DOE/EIS-0297

Griffith Energy Project

Final Environmental Impact Statement

COVER SHEET

Figure 3.4-1
Plant Vicinity Soils Map

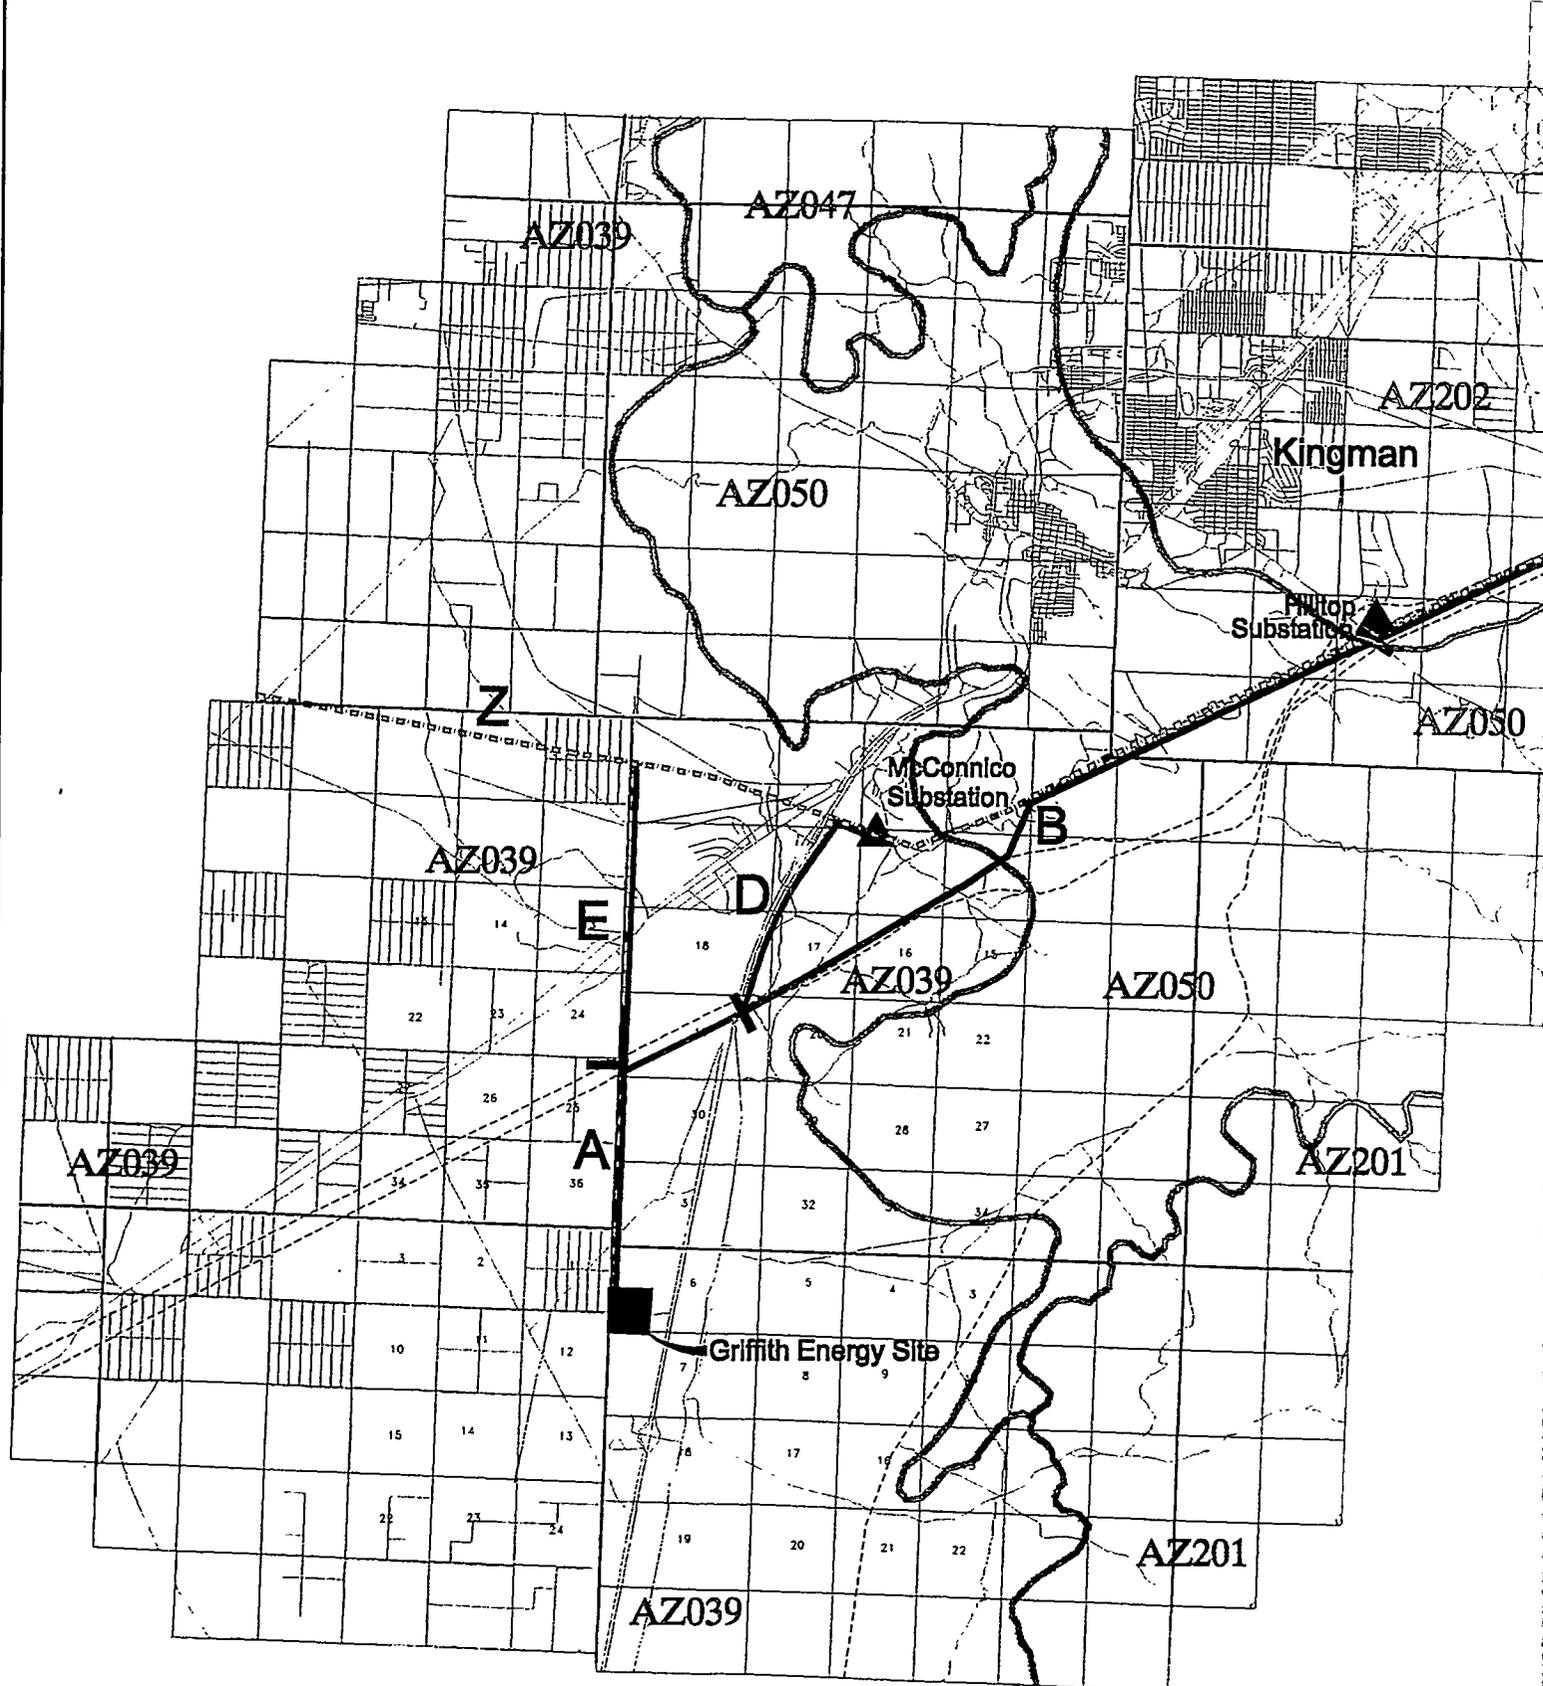
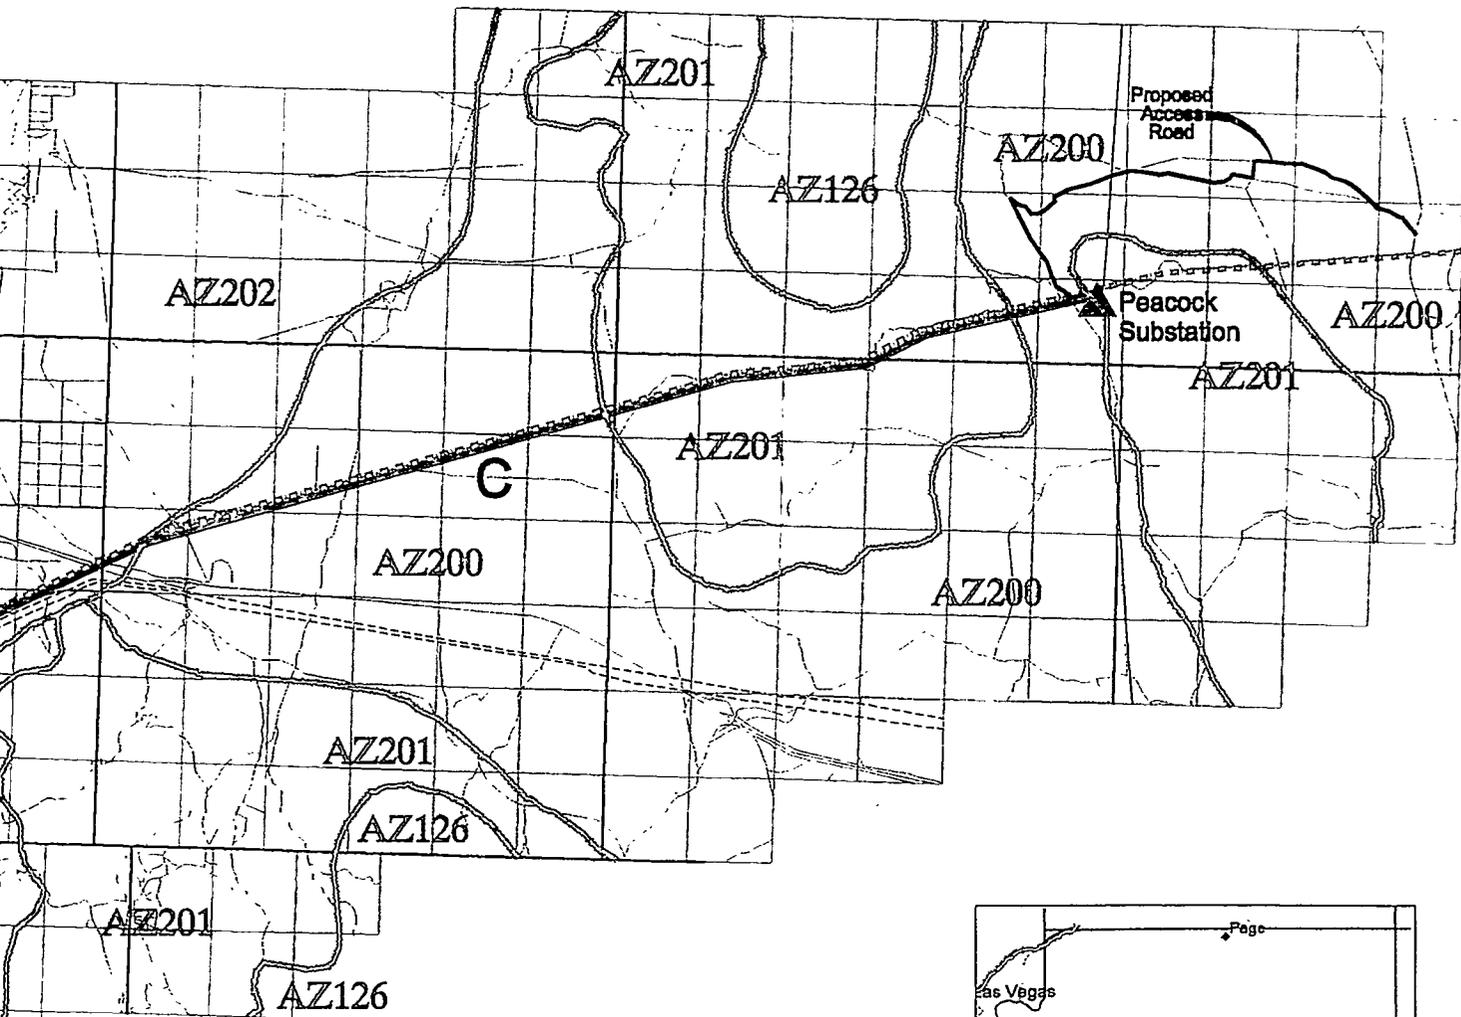
85.	There is no soils map identifying what the soils are in the project area in the list of figures for cross referencing and supporting soils statements in DEIS. Provide a useable one in the text.	Soils maps have been prepared for both the power plant site and associated facilities as well as the transmission line routes. These appear as Figures 3.4-1, 3.4-2, and 3.4-3.

Figure 3.8-2c
Location and Extent of I-40 Industrial Corridor

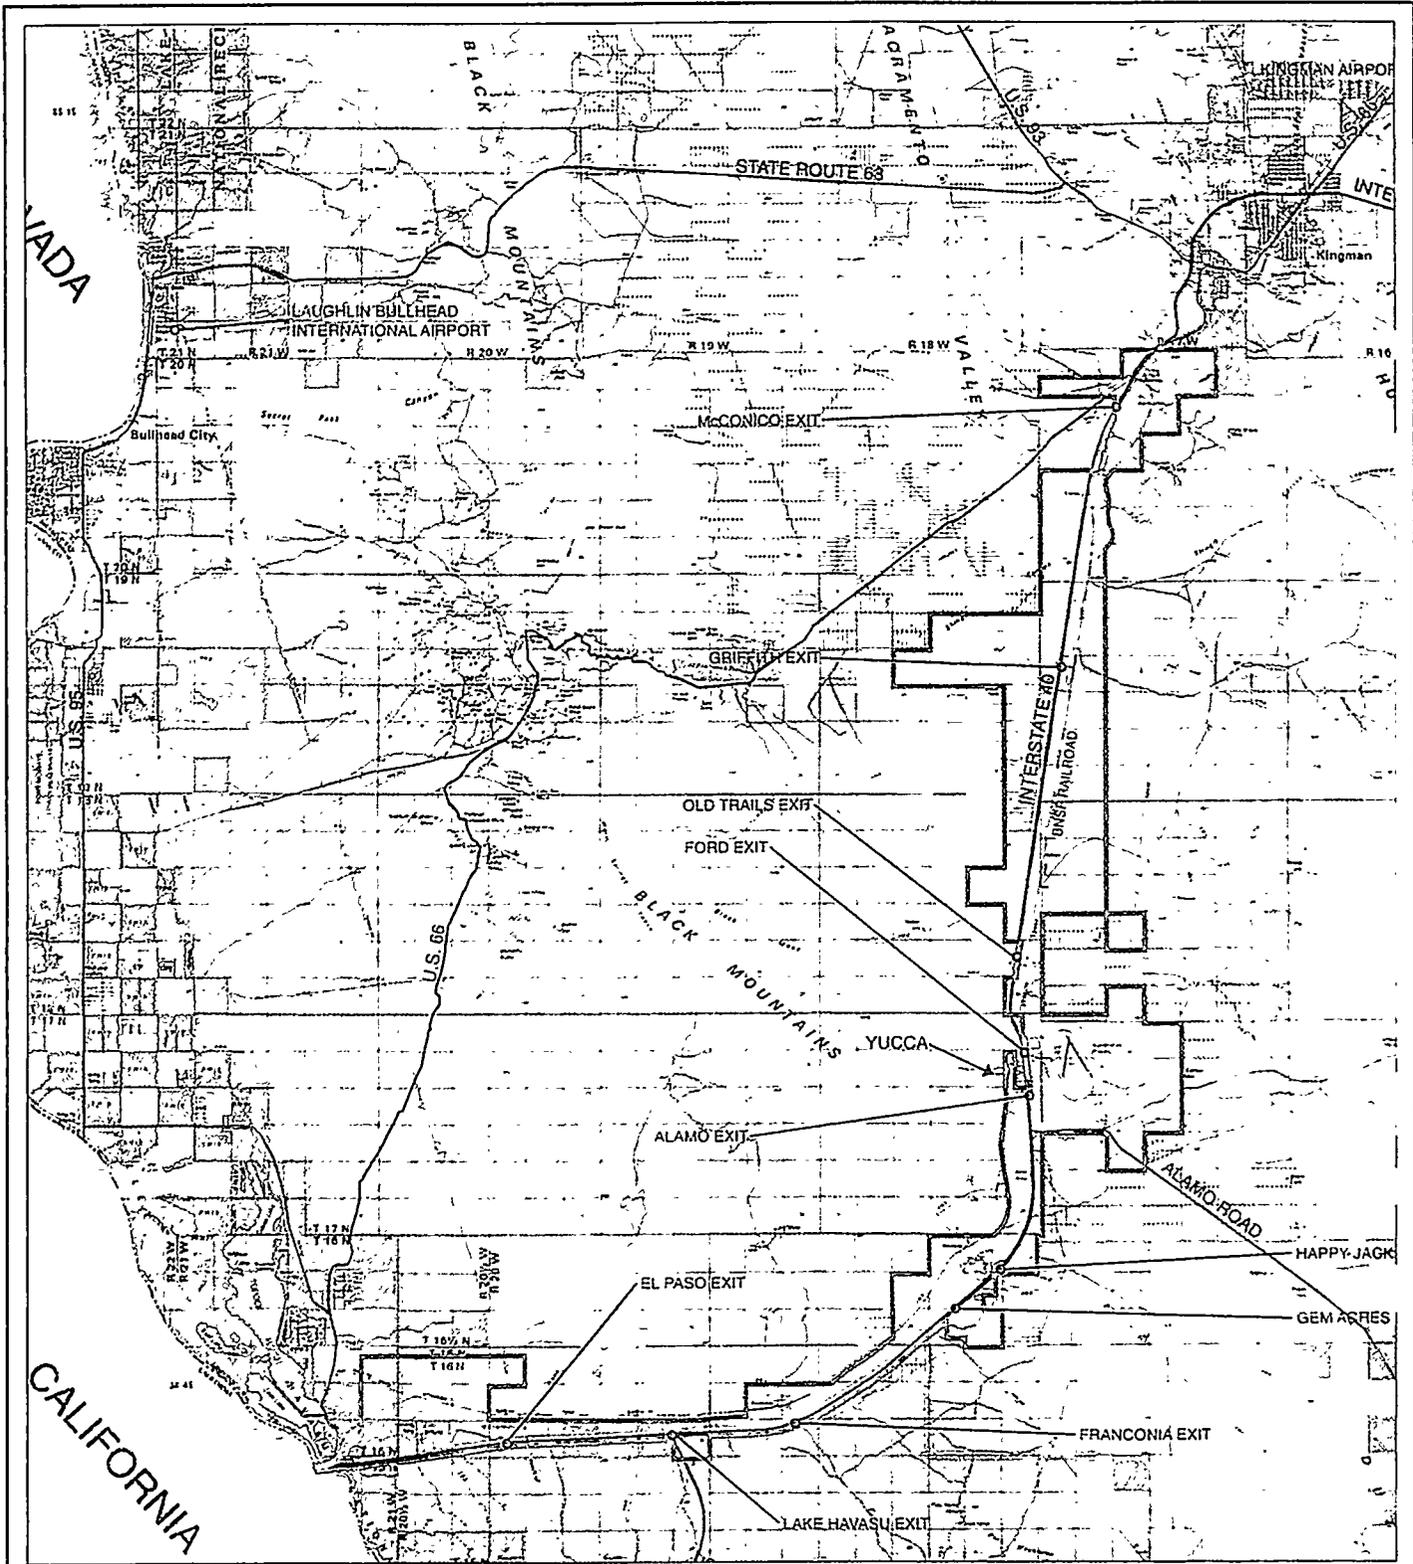
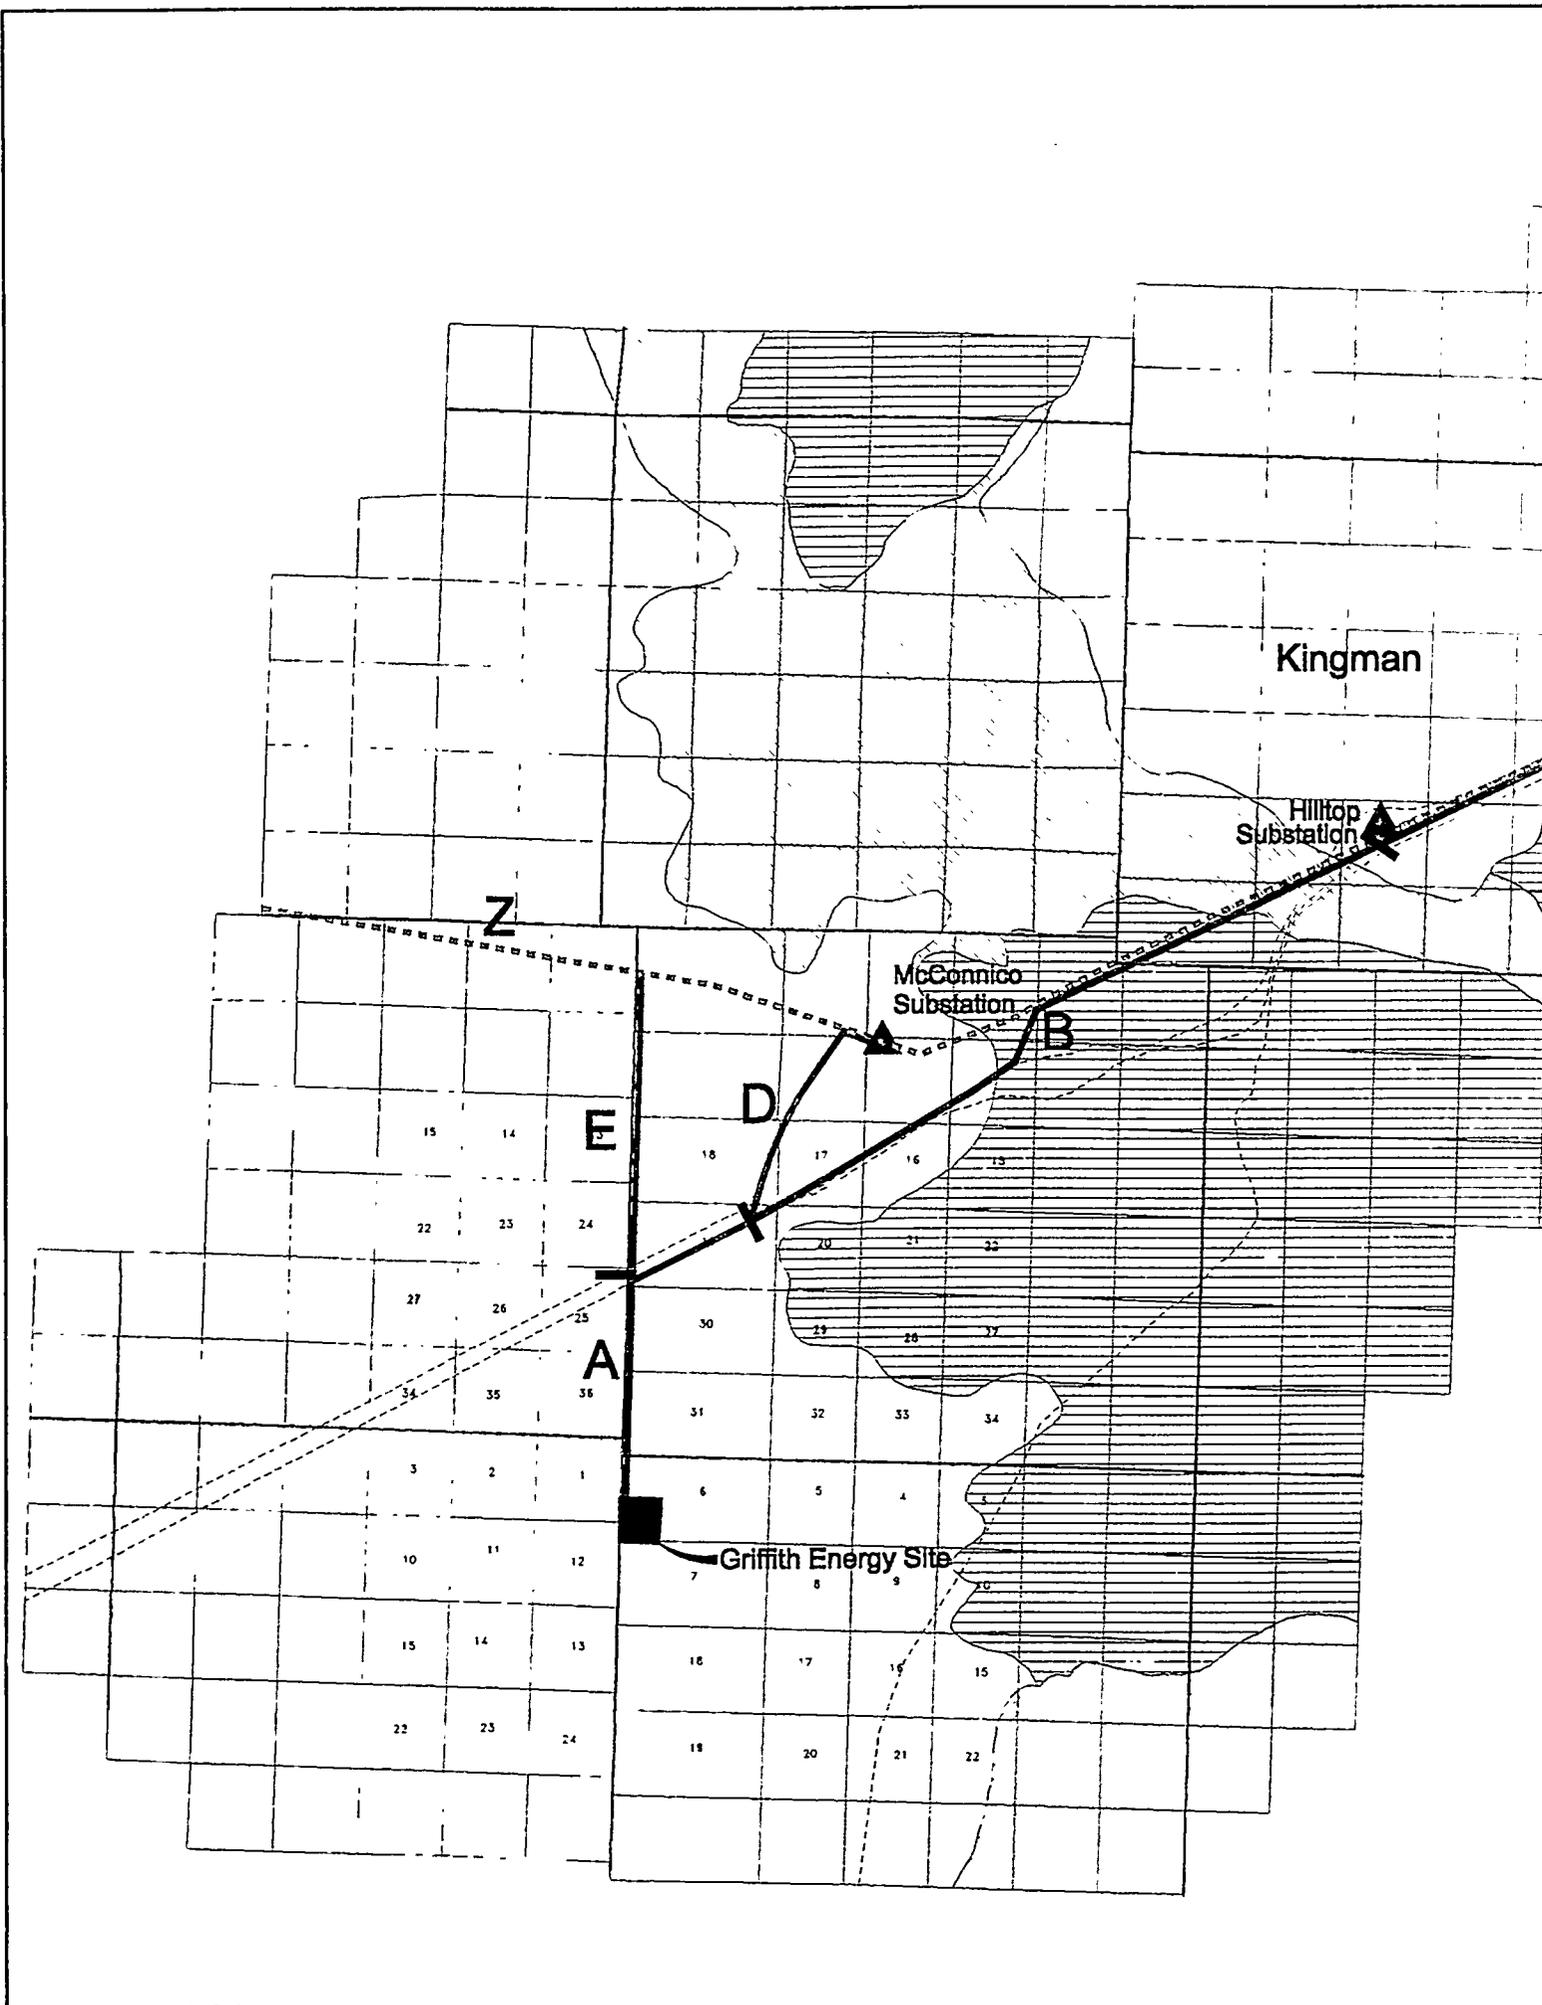
No.	Comment	Response
122.	<p>Western describes an industrial zoned corridor adjacent to the proposed powerplant. In the FEIS the aerial extent and location of the industrial corridor should be shown on a map. Additional information should also be provided on the magnitude and type of activity planned in the future. We also ask that Western explain, under cumulative impacts, the significance of the "future" 230/69-kV transformer and gas compressor area, mentioned on Figure 2.1-1.</p>	<p>The I-40 Industrial Corridor is not adjacent to the proposed power plant. The proposed plant is located within the industrial corridor. The boundary of the industrial corridor is shown on Figure 3.8-2c that has been included in the Final EIS. Seven sections within proposed industrial corridor around the Griffith site have been zoned for industrial development. Other than the County zoning the land for industrial development, there are no current plans for the magnitude and type of activity that could occur there.</p> <p>On Figure 2.1-1, the future gas compressor referenced is space reserved for the addition of a gas compressor for the Griffith Plant should it ever become necessary to boost the pressure of the gas provided by the gas suppliers. Currently, pressures would be adequate for the project but the contingency was added to address the potential for future changes in pressure. The future 230/69-kV transformer was included in the plan because Griffith Energy has agreed to provide a 69-kV tap for the existing Citizens Utilities 69-kV line that runs north-south through the Sacramento Valley. Citizens has indicated that they will not build their approved Kingman-Havasu 230-kV transmission line if the Griffith Project is built. The tap would improve the stability of the existing line if Citizen's doesn't build the 230-kV line. The tap is expected to use the same route as the construction powerline shown on Figure 2.1-3 in the Draft EIS.</p>
